# Access Compliance Report

## Public Rights-of-Way

### (Curb Ramps)

Intersection ID: 8226	Main Street: CATHERINE_SIMMONS_AV	Cross Street: CUSTER_ST	Location: NE
ADA ID: 36C087FA44FB	Ramp Type: PerpDiag	Initial Pass/Fail: Fail	Overall Compliance: No
Severity Score: 12.5			
Codes/Mitigation Info/Possible Solution		Field Measurements/Component Compliance

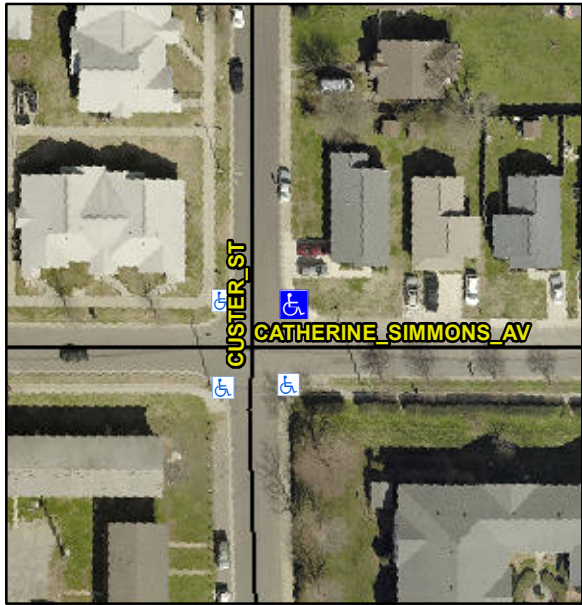
Possible Solutions:					
	Remove & Replace Curb Ramp With Two New Directional Ramps or Equivalent.					
	Surveyor Notes:					
	N/A					
	PROW/ADA:					
Not Found, R304.5.3						
Total Cost:		\$	3200.00

Compliance	Description	Data	Compliance	Description	Data
N/A	Ramp Length (in)	62.0	Yes	Ramp Slope (%)	6.4
Yes	Ramp Width (in)	80.0	No	Ramp XSlope (%)	5.5
N/A	Flare Type LT	N/A	N/A	Flare Type RT	N/A
N/A	Flare Slope LT (%)	N/A	N/A	Flare Slope RT (%)	N/A
N/A	Flare Traversable LT?	N/A	N/A	Flare Traversable RT?	N/A
N/A	Landing Length (in)	N/A	N/A	DWS Provided?	N/A
N/A	Landing Width (in)	N/A	N/A	DWS Contrast?	N/A
N/A	Landing Slope (%)	N/A	N/A	DWS Length (in)	N/A
N/A	Landing X Slope (%)	N/A	N/A	DWS Full Width?	N/A
N/A	Landing Curb? (Y/N)	N/A	N/A	DWS Offset (in)	N/A
N/A	Shared Landing?	N/A			
N/A	Gutter Ponding?	N/A	N/A	Gutter Slope (%)	N/A
N/A	Gutter Lip Ht (in)	N/A	N/A	Gutter X Slope (%)	N/A
N/A	Painted X Walk1?	No	N/A	Painted X Walk2?	No
	X Walk 1 Direction	To W		X Walk 2 Direction	To S
N/A	X Walk 1 Width (in)	N/A	N/A	X Walk 2 Width (in)	N/A
	X Walk 1 Slope (%)	2.6		X Walk 2 Slope (%)	1.7
	X Walk 1 X Slope (%)	0.6		X Walk 2 X Slope (%)	1.5

N/A	Ramp inside XWalk1?	N/A	N/A	Ramp inside XWalk2?	N/A
	Road Slope (%)	1.3	N/A	Clear Space?	N/A
	Road X Slope (%)	3.2	N/A	Clear Space to XWalk (in)	N/A
N/A	Any Obstructions?	N/A	N/A	Storm Grate/Utility Hazard?	N/A
	Obstruction Type			Storm Grate/Utility Type	
		N/A			N/A
			Yes	Surface Condition? (G/P)	Good
